Access Compliance Report

Public Rights-of-Way

(Curb Ramps)

Intersection ID: 10041519	Main Street: WEYMOUTH_LN	Cross Street: N/A	Location: NW
ADA ID: 84F1027D9A1C	Ramp Type: Perp	Initial Pass/Fail: Fail	Overall Compliance: No
Severity Score: 12.5			
Codes/Mitigation Info/Possible Solution		Field Measurements/Component Compliance

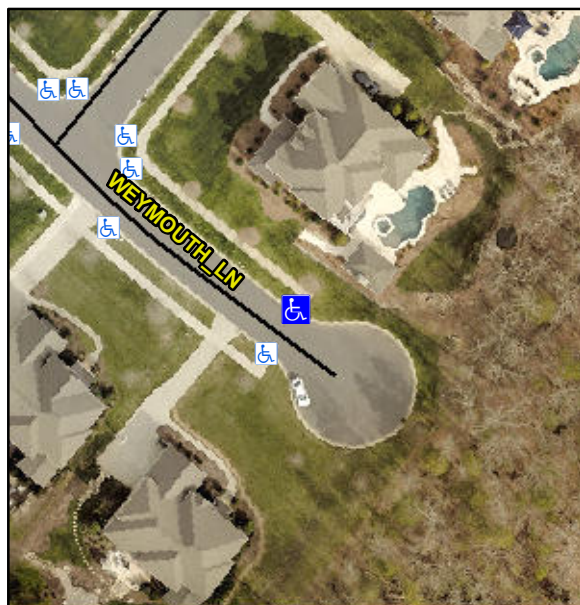
Not Found, R304.5.3

Compliance	Description	Data	Compliance	Description	Data
N/A	Ramp Length (in)	47.5	Yes	Ramp Slope (%)	7.2
Yes	Ramp Width (in)	48.0	No	Ramp XSlope (%)	5.2
N/A	Flare Type LT	N/A	N/A	Flare Type RT	N/A
N/A	Flare Slope LT (%)	N/A	N/A	Flare Slope RT (%)	N/A
N/A	Flare Traversable LT?	N/A	N/A	Flare Traversable RT?	N/A
N/A	Landing Length (in)	N/A	N/A	DWS Provided?	N/A
N/A	Landing Width (in)	N/A	N/A	DWS Contrast?	N/A
N/A	Landing Slope (%)	N/A	N/A	DWS Length (in)	N/A
N/A	Landing X Slope (%)	N/A	N/A	DWS Full Width?	N/A
N/A	Landing Curb? (Y/N)	N/A	N/A	DWS Offset (in)	N/A
N/A	Shared Landing?	N/A			
N/A	Gutter Ponding?	N/A	N/A	Gutter Slope (%)	N/A
N/A	Gutter Lip Ht (in)	N/A	N/A	Gutter X Slope (%)	N/A
N/A	Painted X Walk1?	No	N/A	Painted X Walk2?	N/A
	X Walk 1 Direction	To SW		X Walk 2 Direction	N/A
N/A	X Walk 1 Width (in)	N/A	N/A	X Walk 2 Width (in)	N/A
	X Walk 1 Slope (%)	2.8		X Walk 2 Slope (%)	N/A
	X Walk 1 X Slope (%)	2.3		X Walk 2 X Slope (%)	N/A

Remove & Replace Entire Ramp.
